From: Klaus Kerzinger <klausk@ballina.nsw.gov.au>
Sent: Tuesday, 10 May 2016 3:57 PM
To: Helen Carpenter
Subject: Bike Plan Matter

Re: Broad Community Support for Beachfront Parade Green/Grassed Footpath Reserve vs Bike Plan (Draft) Proposed Shared Path.

Map 1

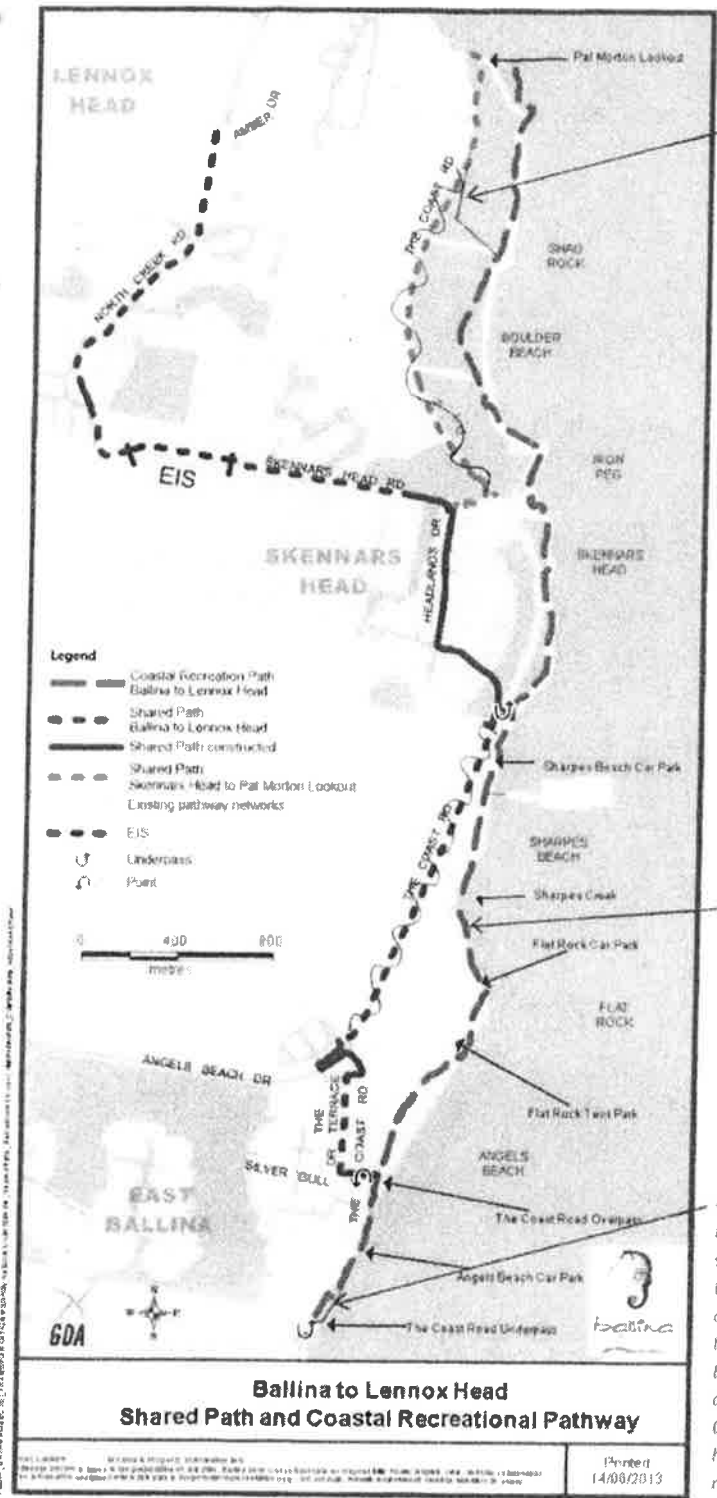
3. The Coast Road shared path from Pat Morton Lookout to Skennars Head should be realigned from chainage 5,500m (at northern end of the Dry Stone Wall) (see map 1 & Figure 1), to ensure that the shared path continues to follow the existing mowed path to the southern end of the Dry Stone Wall or the Tuckeroo tree as seen Figure 2 and then proceed in a south east direction on the Existing Emergency vehicle track as seen in Figure 3 to connect with Coastal Recreational Path at Lennox Point chainage 5,157m.

The share path from Pat Morton Lookout to Skennars Head should be realigned from chainage 5500 at northern end of the Dry Stone wall (Figure 1), to ensure that the Shared Path continues to follow the existing mown path to the southern end of Dry Stone Wall or Tucker Roo tree as seen Figure 2 and then proceed in a south east direction on the existing emergency vehicle track as seen in figure 3 to connect with Coastal Recreational Path near the northern end of the timber board walk that spans over Boulder Beach wet land.
